HISTORIC AND DESIGN REVIEW COMMISSION

December 21, 2022

HDRC CASE NO: 2022-574
ADDRESS: 145 NAVARRO ST
LEGAL DESCRIPTION: NCB 986 LOT 11 THRU 13 AND E 5.14FT OF 10
ZONING: D, H, RIO-3
CITY COUNCIL DIST.: 1
APPLICANT: Peter Ketter/Sandvick Architects Inc.
OWNER: Kunal Mody/145 NAVARRO LLC
TYPE OF WORK: Construction of a rooftop addition, fenestration modifications, window replacement, rehabilitation, canopy installation and signage
APPLICATION RECEIVED: December 02, 2022
60-DAY REVIEW: Not applicable due to City Council Emergency Orders
CASE MANAGER: Edward Hall
REQUEST:

Proposed Exterior Alterations
HDRC Conceptual Review – December 2022

4
A3.6
1/8" = 1'-0"
0 2' 4' 8' 16'

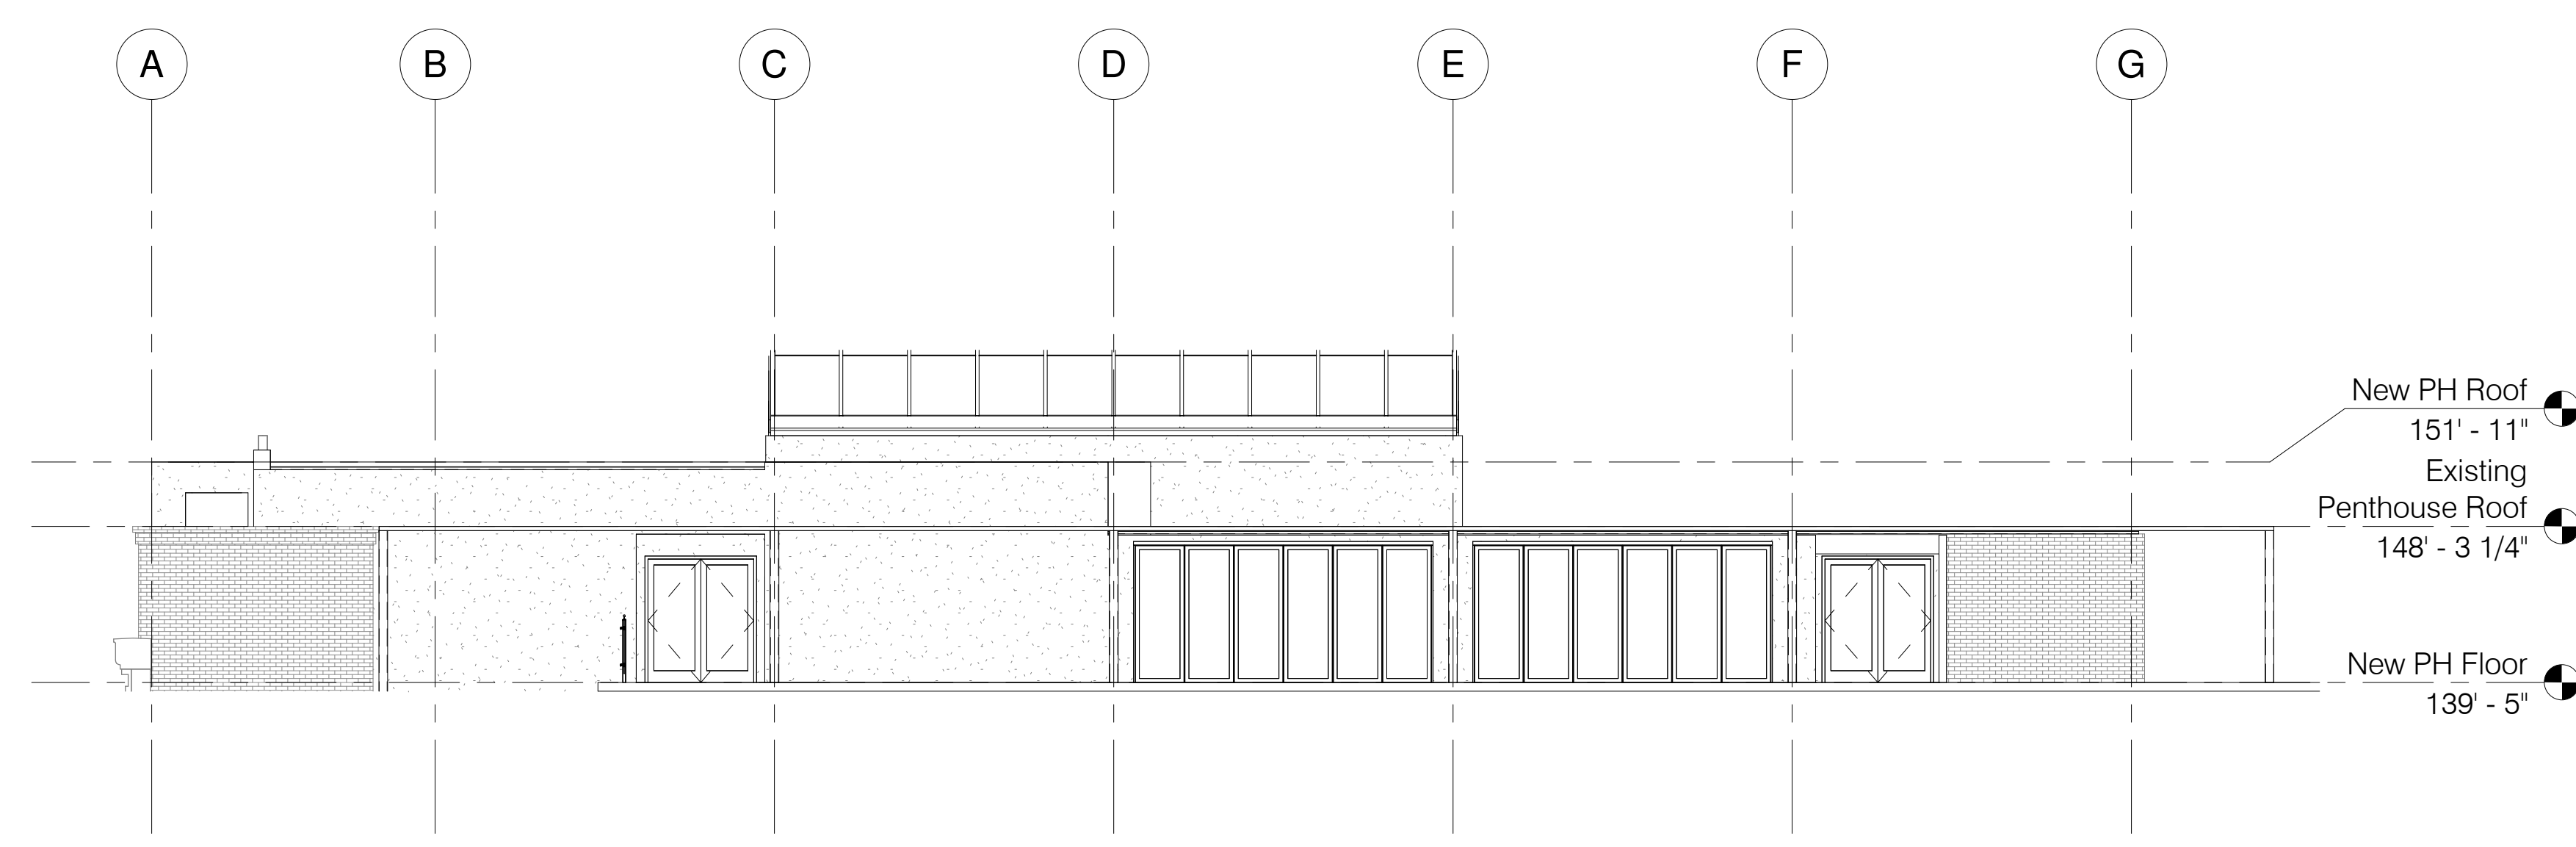
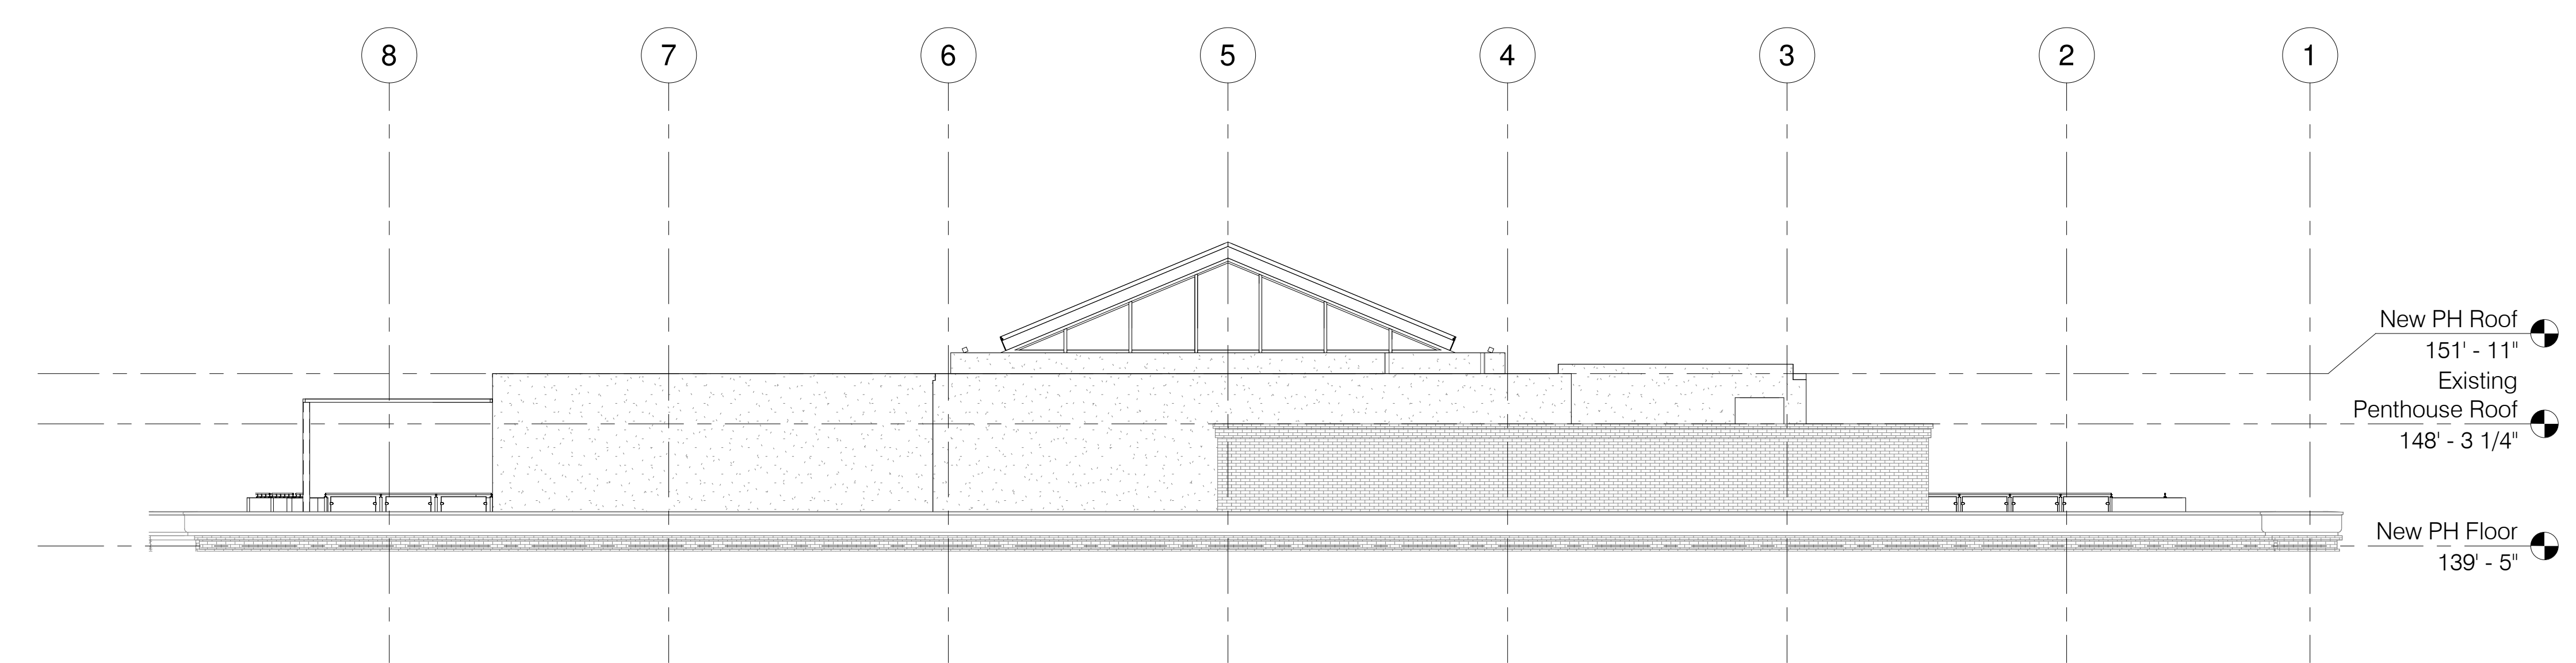
- j. **ADDITION** – The applicant has proposed to construct a rooftop addition to feature 1-story in height and approximately 3,700 square feet. The applicant has noted that the proposed addition will feature setbacks from the south, east, northeast and north facades.

- k. **ADDITION** – Per the Guidelines for Additions 2.A., new additions should be designed to be in keeping with the existing, historic context of the block and should be located to minimize visual impact from the public right of way. Additionally, the Guidelines for Additions 1.B.i. notes that the height of a rooftop addition should not be more than forty (40) percent of the original height of the structure. Staff finds that the proposed massing of the addition features massing that will be minimally visible from the right of way.

- l. **ADDITION (Materials)** – The applicant has proposed materials that include brick, stucco, metal coping and aluminum windows and storefront systems. Generally, staff finds the proposed materials to be appropriate and consistent with the Guidelines. Final material specifications should be provided for future review and approval. Additionally, staff finds that all windows should be consistent with staff's standards for windows in new construction and additions.

- m. **ADDITION (Architectural Details)** – The applicant has proposed architectural details that present a massing, materials and general design that is subordinate to the details and massing of the historic structure. Staff finds the proposed architectural details to be appropriate and consistent with the Guidelines.

8. Staff recommends approval of item #8, the construction of a rooftop addition, based on findings j through m, with the following stipulation:
 - i. That final materials specification be provided for future review and approval.

- ii. That the addition feature dark colored materials and paint colors.
9. Staff recommends approval of item #9, canopy signage, with the following stipulations. Staff recommends the following.
